PLANNING RESPONSES
SUNLIGHT HOUSE
APRIL 2023

EXTERNAL ALTERATIONS

INTERNAL ALTERATIONS

APPLICANT RESPONSE

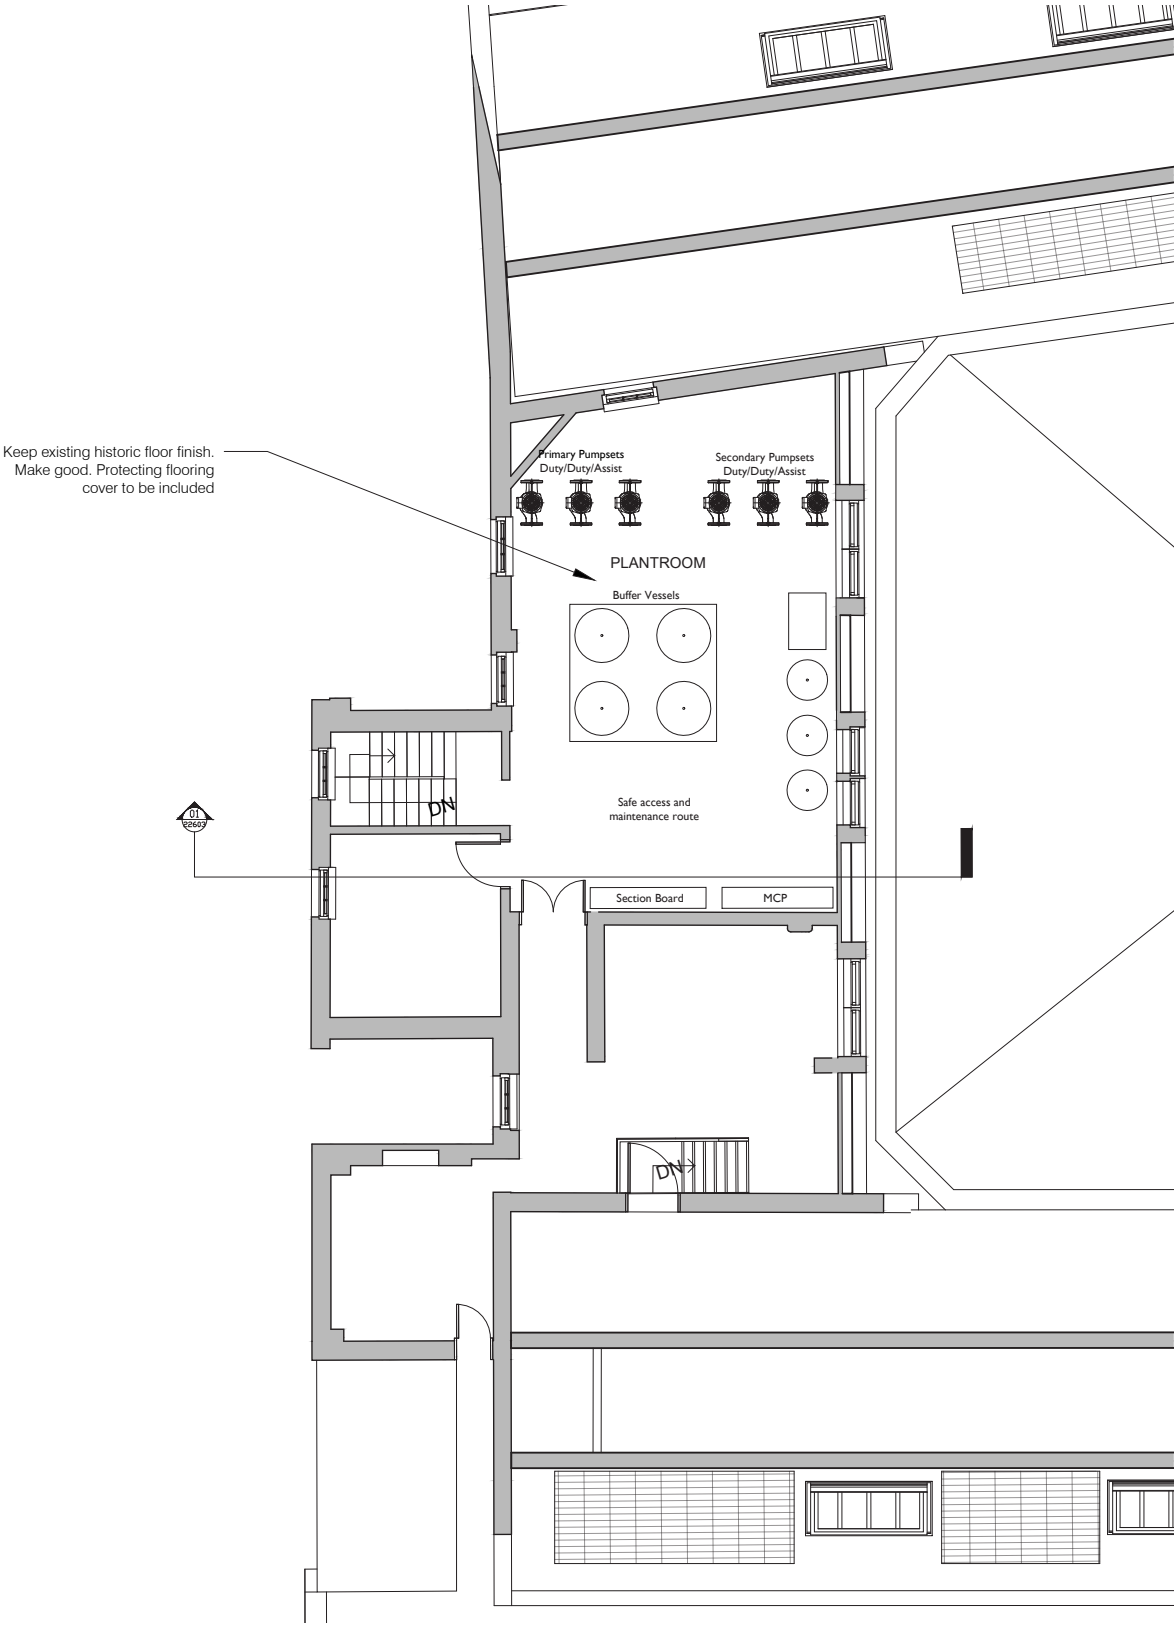
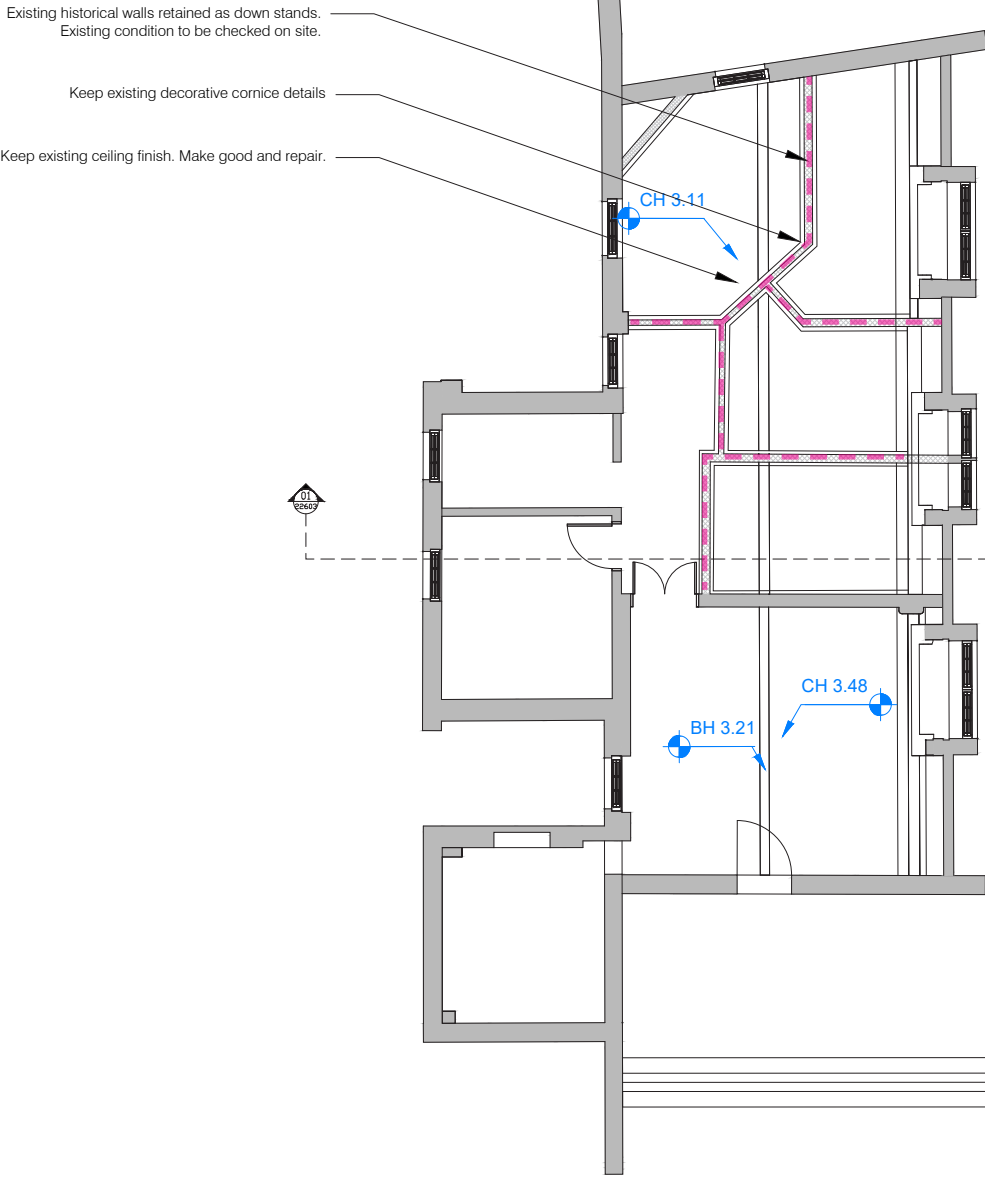
There is a dispute about the extent of original features in this space with elements of original floorplan, cornicing, window surrounds, parquet floor and white glazed tiles all evident in this space. Indeed, the photograph show the parquet floor largely intact. It is accepted that most of the partitions are modern but reflect the original subdivision. To that end the removal of the partitions would cause a degree of harm. Did you undertake a options analysis to look at alternative locations of the plant before deciding of this area? We would like to explore with you whether more of the original layout could be retained including partitions and repair and reinstatement of features such as the floor, ceilings, stairs, metal work and handrails.

The challenge we face in this area is the balance between access, maintenance and heritage. We discussed on site that this area was weighed up against the level 13 space as potential on site plant space, with this area deemed more appropriate due to its condition, inaccessibility and already housing significant lift and heating plant in the area.

In this diagram, the scale and size of proposed equipment is visible. Maintaining the small doorways and non original wall presents a problem for installation and maintenance of this kit.

Note on the facing RCP survey the misalignment between the downstand beam and the wall layout.

Original partitions (in dashed pink line) will be retained as downstands. Original ceiling will be repaired. Protective flooring cover will be included over existing heritage floor finish.

25. LEVEL 14 PLANT ROOM

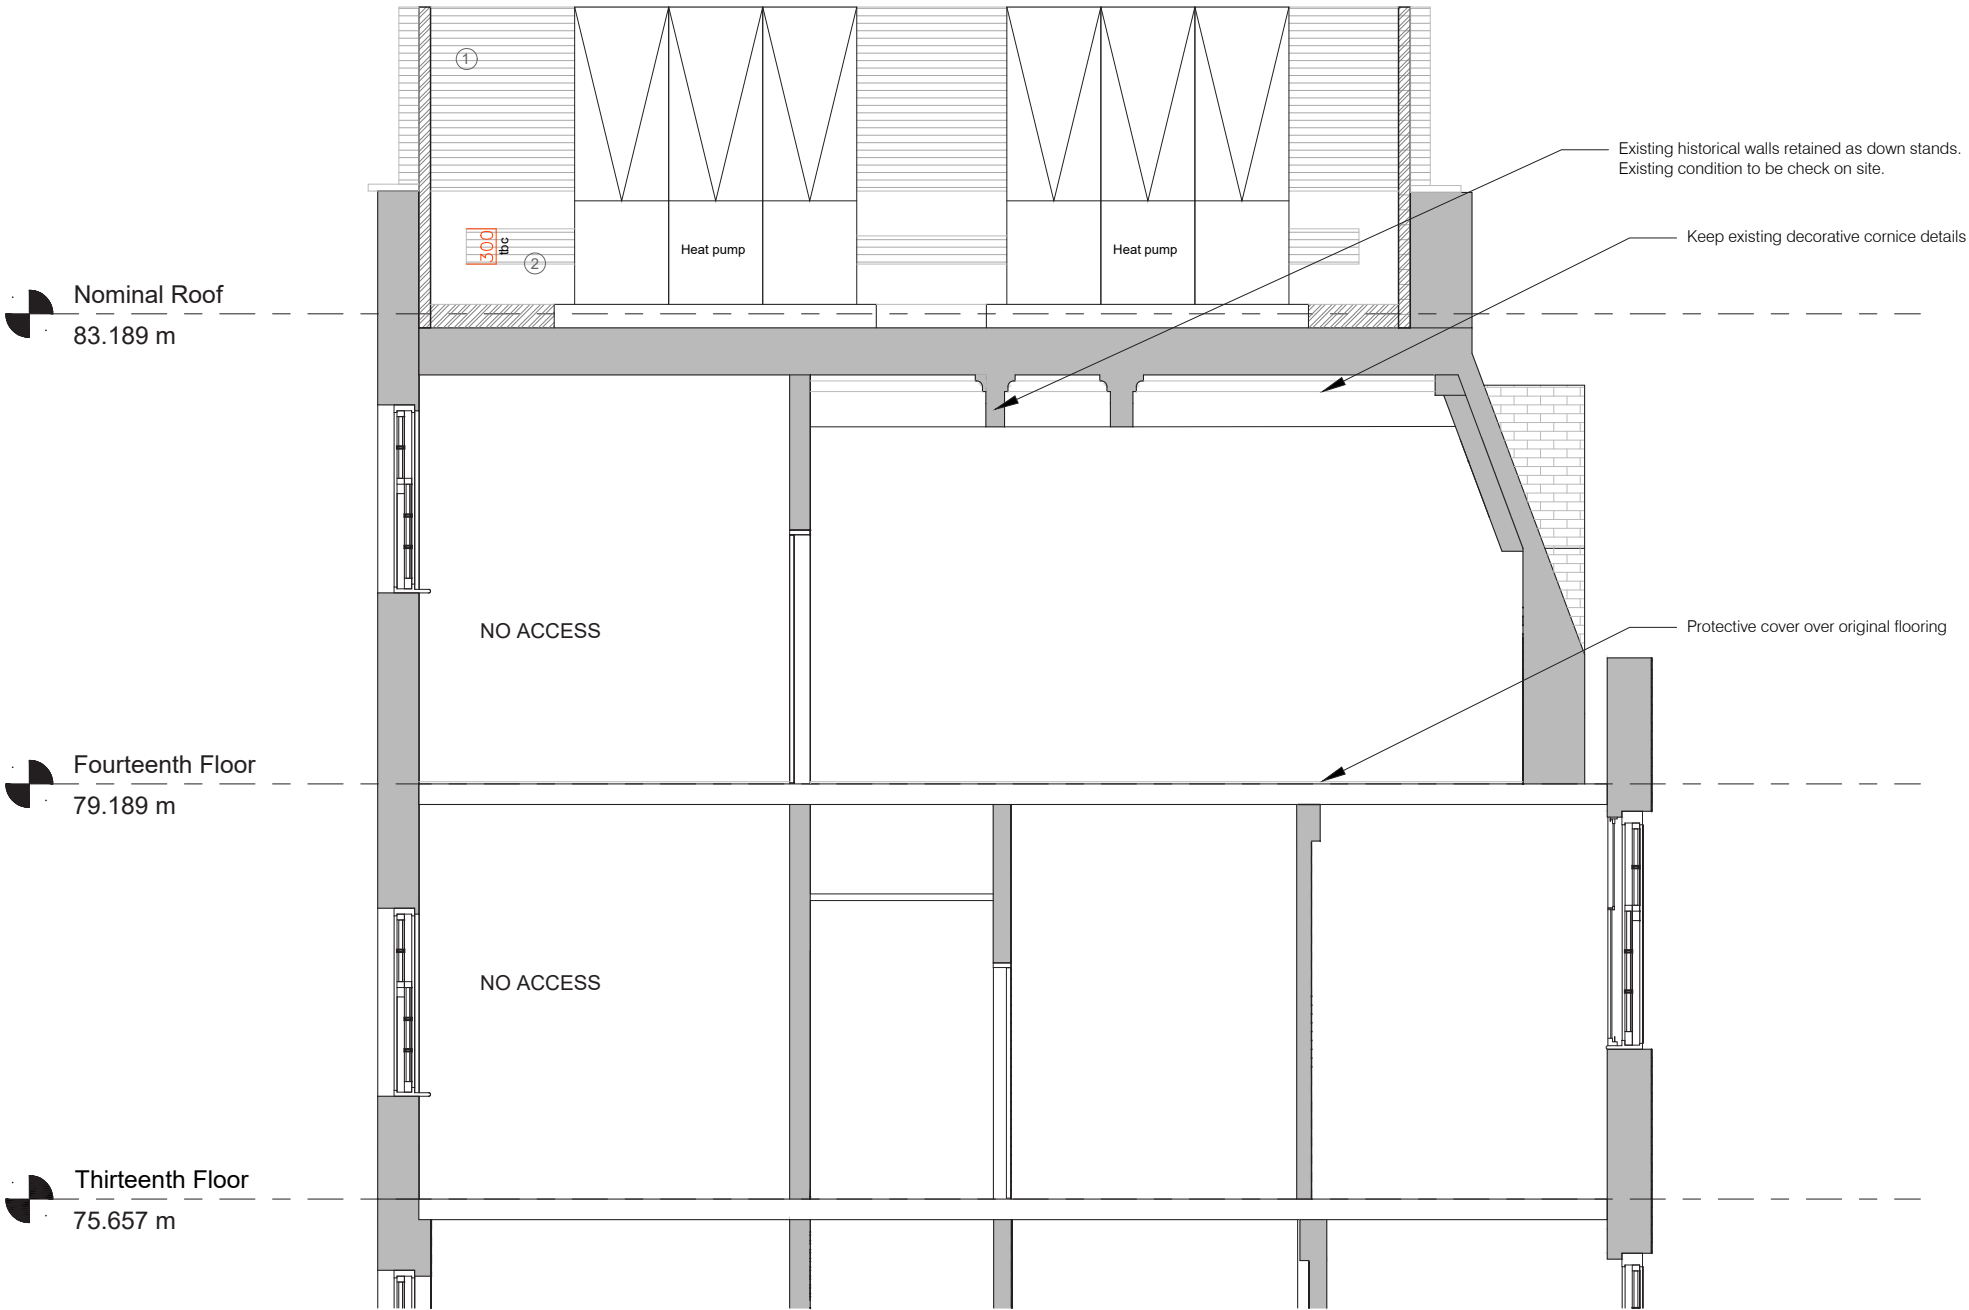
There is a dispute about the extent of original features in this space with elements of original floorplan, cornicing, window surrounds, parquet floor and white glazed tiles all evident in this space. Indeed, the photograph show the parquet floor largely intact. It is accepted that most of the partitions are modern but reflect the original subdivision. To that end the removal of the partitions would cause a degree of harm. Did you undertake a options analysis to look at alternative locations of the plant before deciding of this area? We would like to explore with you whether more of the original layout could be retained including partitions and repair and reinstatement of features such as the floor, ceilings, stairs, metal work and handrails.

Note - proposal is to create downstand nibs in wall current locations and maintain coffered ceiling to acknowledge their location.
